C 19.1

Subject: RE: 30 nashville File Name: 2385388 Ontario Inc. and File Numbers: OP.15.005 &

Z.15.024): Trees

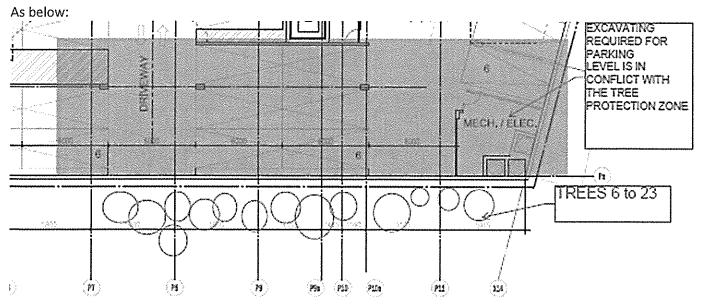
In contrast, the Proposals Parking Level Plan indicates excavating requirements that would infringe the TPZ of all these trees.

1) How does this proposal satisfy the requirements for its Tree Protection Zone in its arborist report?
